# OVERLAND RANCH PORCHVIEW PARK

## SITE PLAN

OVERLAND RANCH PORCHVIEW PARK  
SITE PLAN  
AURORA, CO

SHEET TITLE:  
COVER SHEET

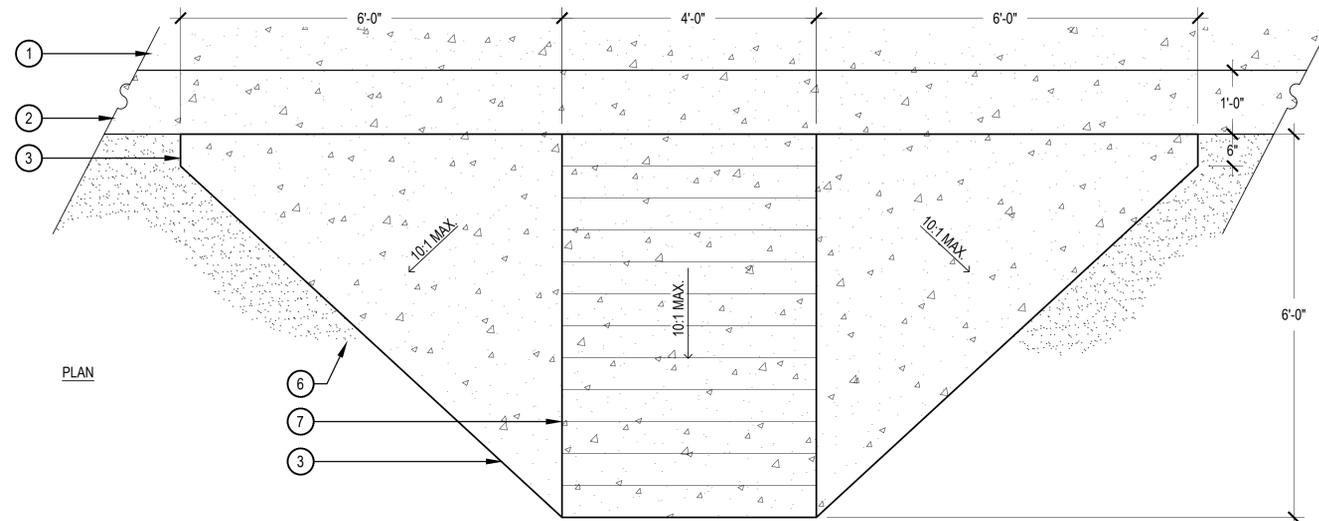
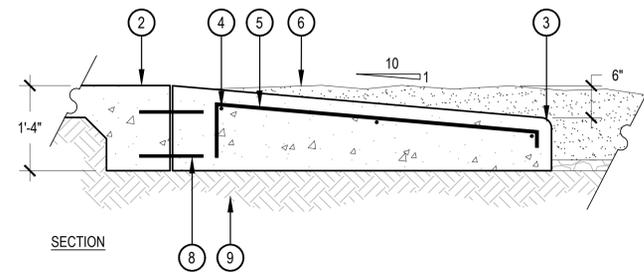
Include a detail for the fencing proposed around the pickle ball courts.

Provide a detail for the larger shade structure. Section 6.22.E of the PROS Dedication and Development Criteria Manual notes that picnic shelters should be in relation to the size and service area of the park. For Neighborhood Parks the minimum acceptable size is 600 square feet with seating for 15 people.

Provide a detail for the picnic tables. These tables should be ADA accessible.

ND Response: Refer to Detail 3, Sheet 15 for pickleball court fence.

ND Response: Detail for picnic table has been added to the plan as well as the detail sheets. Product chosen is able to be manufactured as ADA accessible and the ADA accessible tables are being shown on the plan as such.

SHEET TITLE:  
SITE LIGHTING  
PHOTOMETRIC

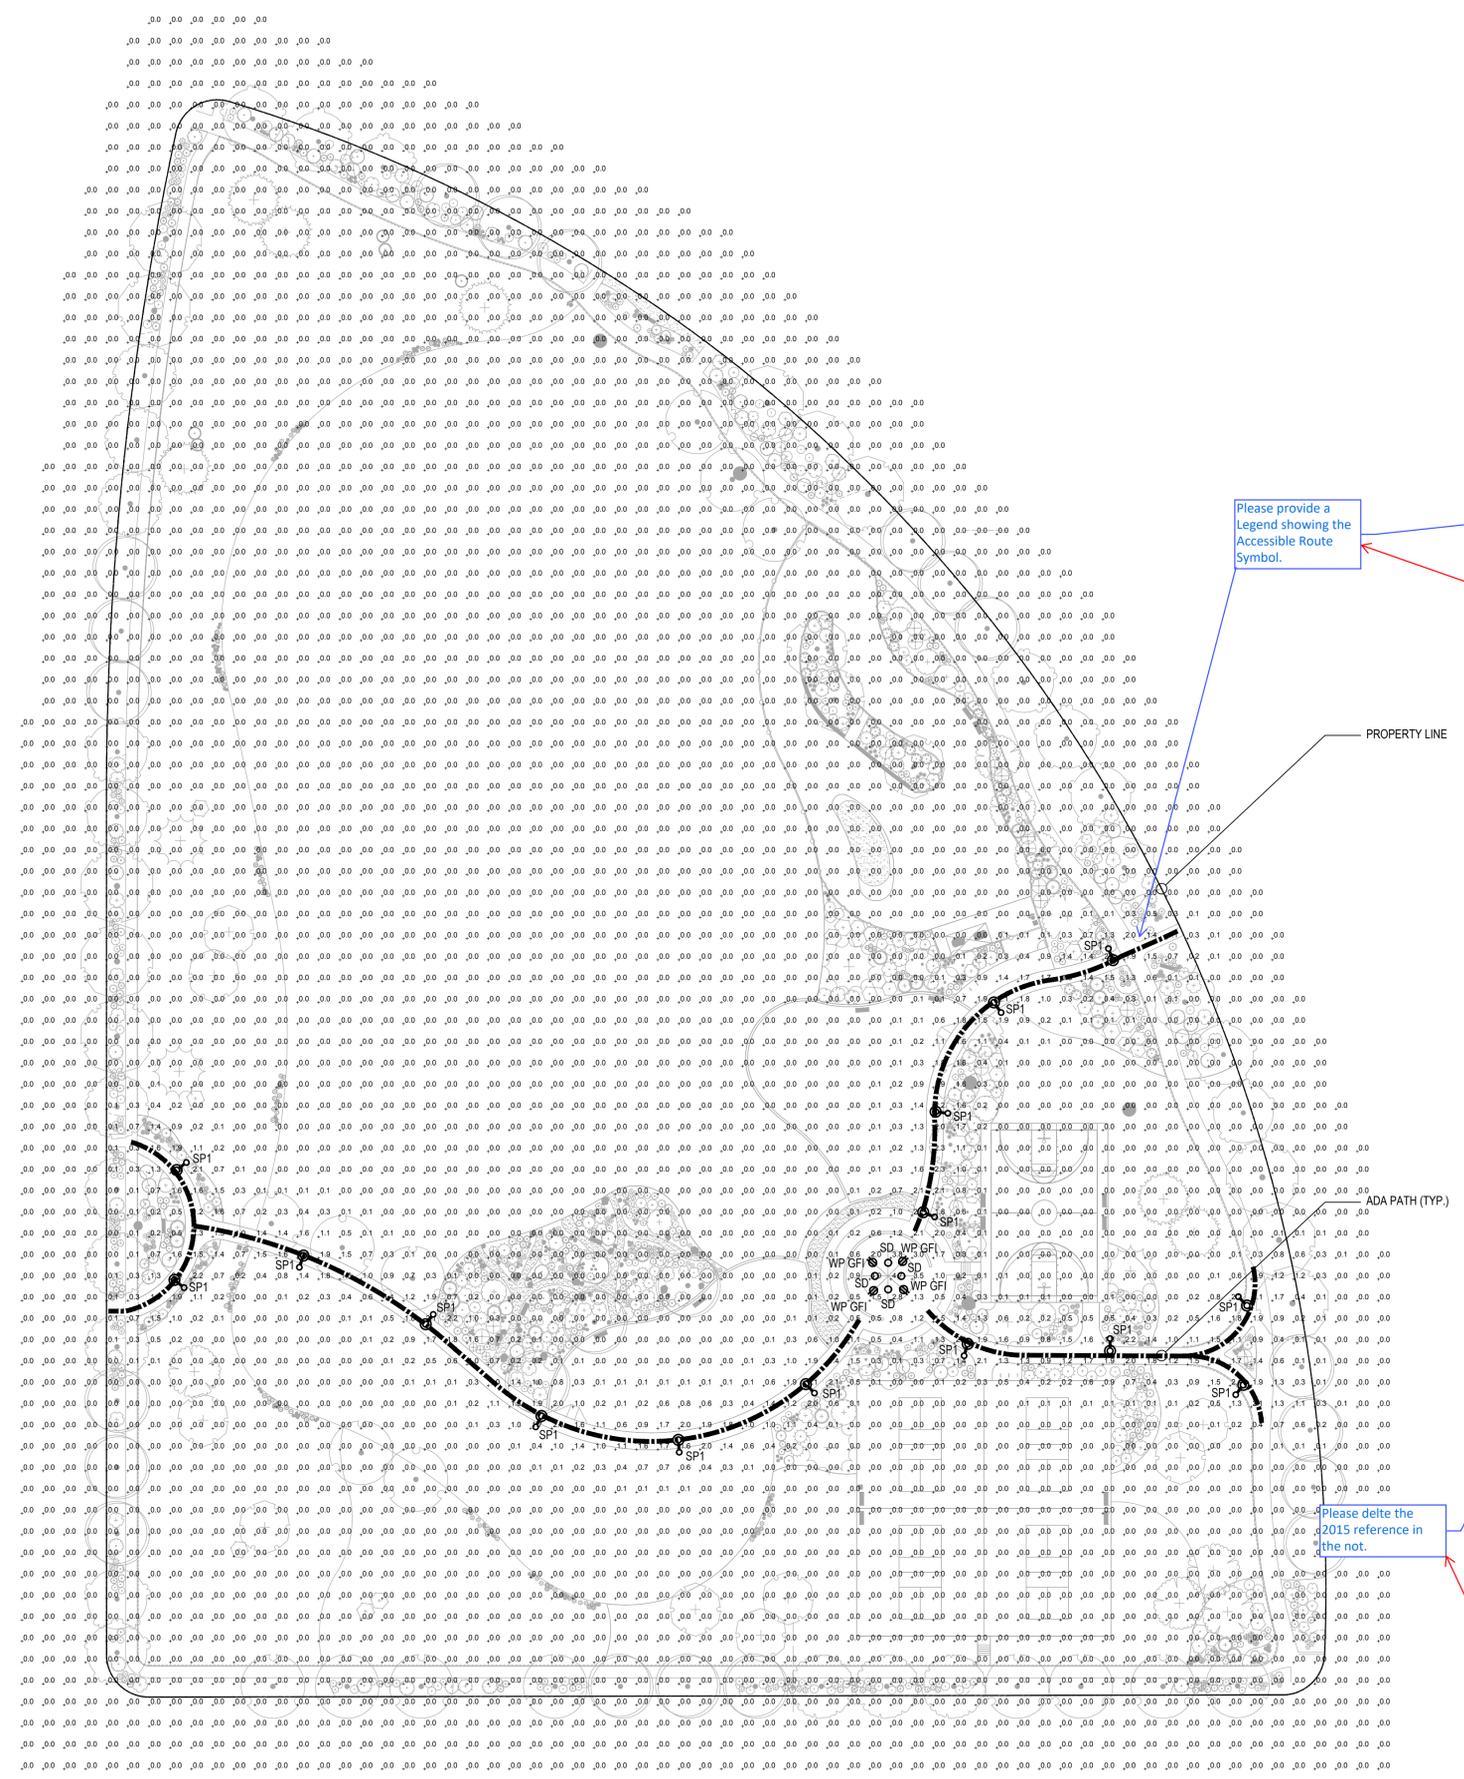
Please provide a Legend showing the Accessible Route Symbol.

Please delete the 2015 reference in the not.

SL Response 1/14/25; Legend added.

SL Response 1/14/25; Note revised.
